Service Bulletin No. 279C

MODEL F3500 Series Coaches	TYPE Field Change Program	SECTION/GROUP 11-Steering	DATE Aug. 7, 2007
SUBJECT STEERING ARM IDLER BRACKET			
CONDITIONS

Ref. NHTSA Recall No.: 07V-191

Figure 2. Top view of front bogie. Inspection required of four locations.

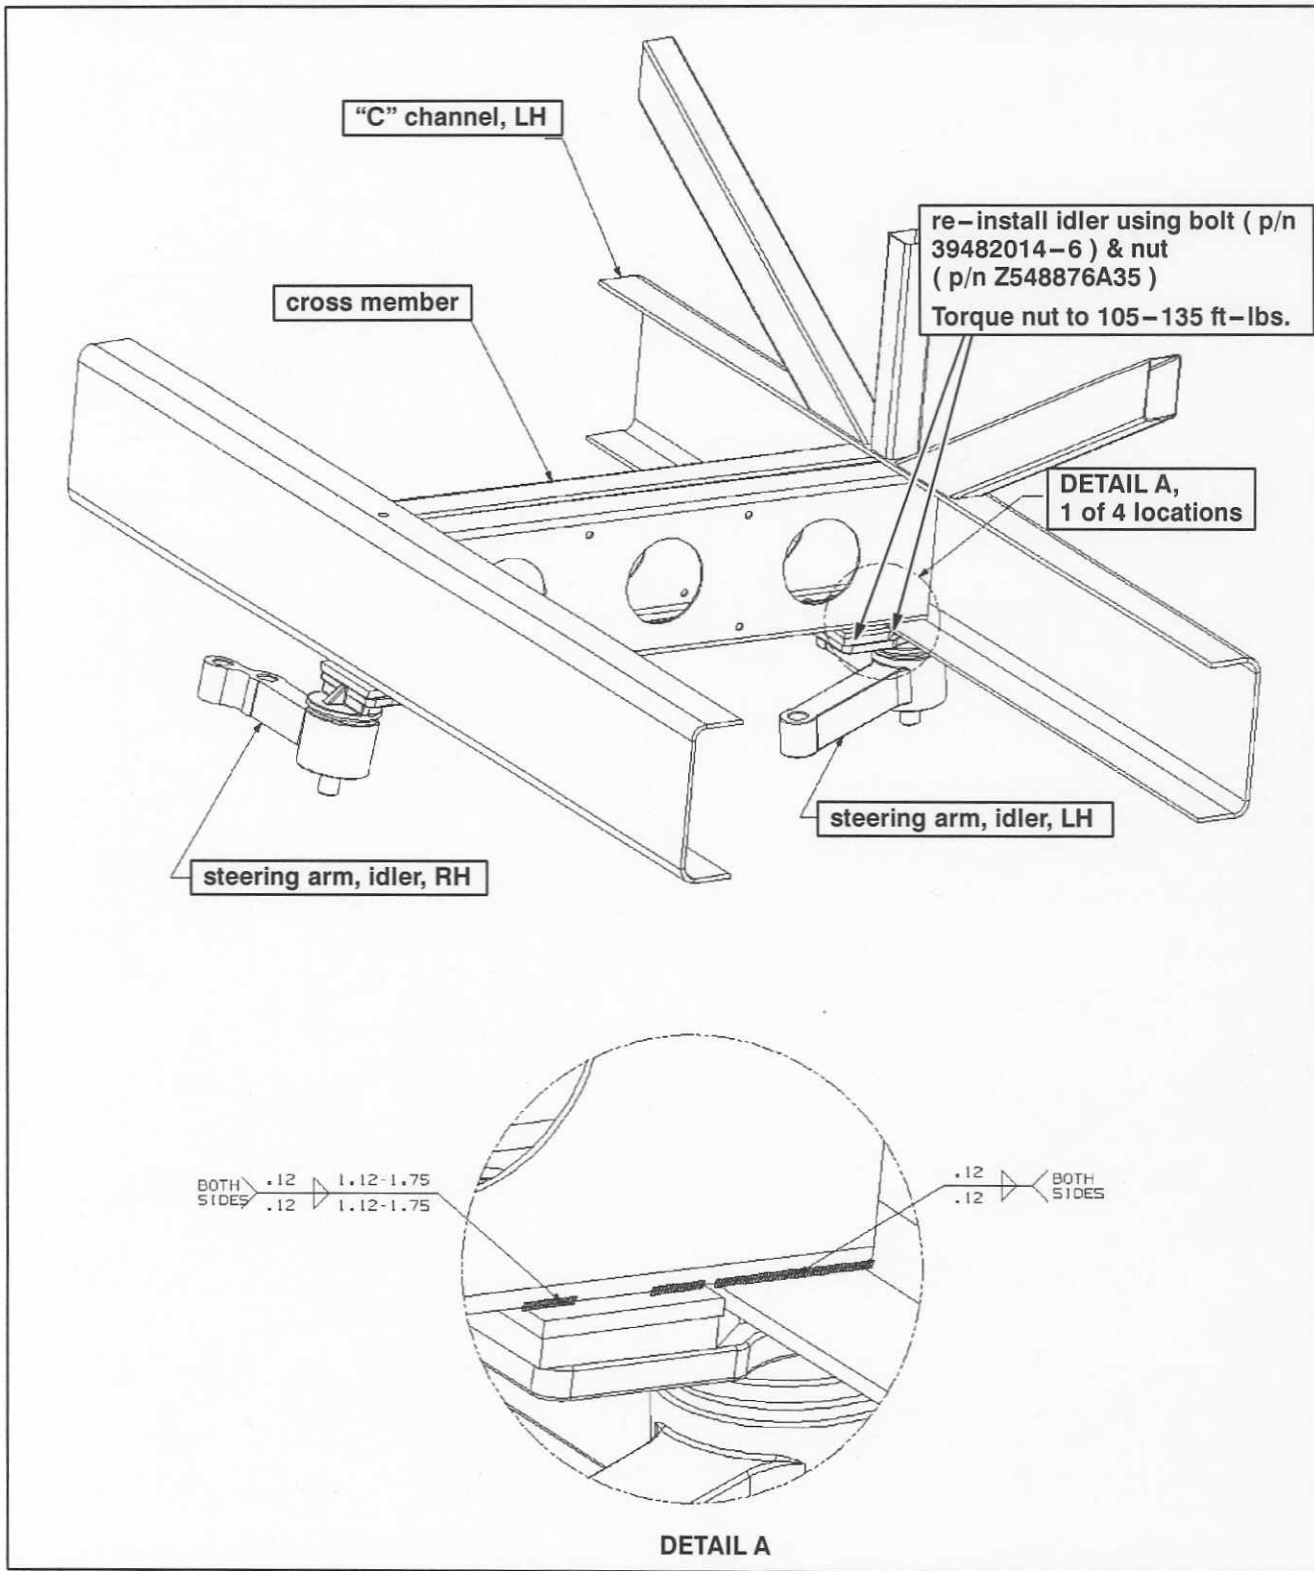
Customer can experience cracking, originating at the heat-affected zone of the weld at the steering arm idler bracket location.

MCI determined that the cracking had originated at the heat-affected zone of the weld at the steering arm idler bracket location, apparently as a result of insufficient welding process during manufacture. If not identified and repaired during regular maintenance and inspection, the cracking could allow movement of the idler plate, and over an extended period of time progress and result in reduced steering control or steering loss if total failure of the mounting occurred.

6. Inspect the four weld areas shown in Figure 2 / Detail A and the two weld areas shown in Figure 3 / Detail B.
7. If a crack is present, at the location shown in Figures 2 and 3:

- a. drill a 1/8 inch hole at the extreme end of the crack,
 - b. bevel both sides of the crack to create a V groove,
 - c. run a continuous weld, ensuring full penetration,

- d. grind the weld flush with the face of the plate.
8. Locate the existing suspension plate shown in Figure 4 / Detail A. Remove and discard the existing suspension plate and mounting hardware. Install the new suspension plate (p/n 12-01-1252) using the mounting hardware provided (p/n 19-1-994, 19-02-0383 and 19-03-0582). Hand-tighten and snug the nut's. Repeat to the opposite side. Weld the suspension plates, using the weld size and location in Figure 4 / Detail A.

MCI will add reinforcement gussets to all of the coaches identified in order to reduce stress where cracking can occur and to repair the existing components in the affected units as necessary.

Figure 4.

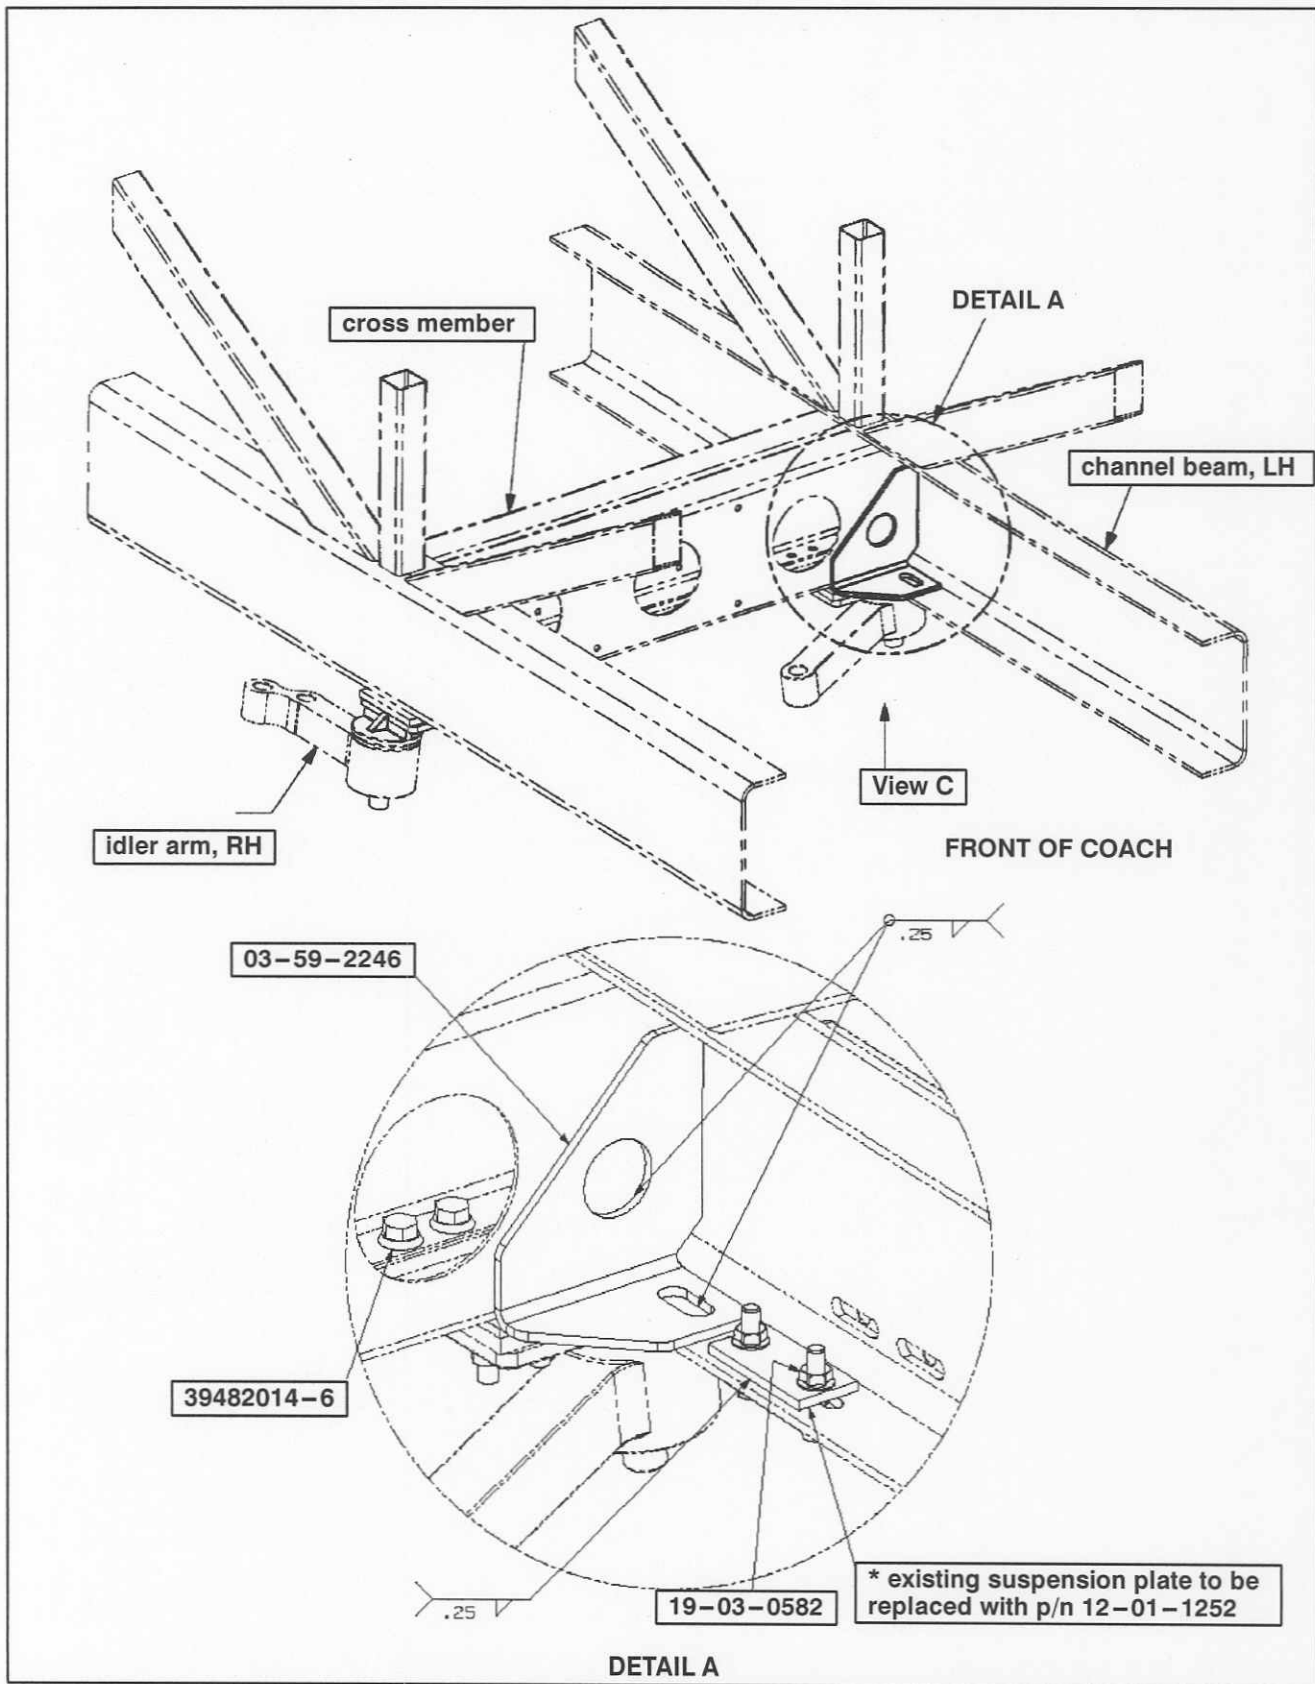
9. Tack weld the angles (p/n 03-59-2246 and 03-59-2247) into position, according to Figures 4 and 5.
10. Weld the angles, using the weld sizes and locations in Figures 4, 5 and 6.

11. Apply rust paint to the installation area.
12. Torque the suspension plate nut's to 50-75 ft.-lbs.
13. Re-install the steering arm idler, removed in Step 3. , using bolt (p/n 39482014-6) and nut (p/n Z548876A35) (Figures 4, 5 and 6). Torque nut to 105-135 ft.-lbs.
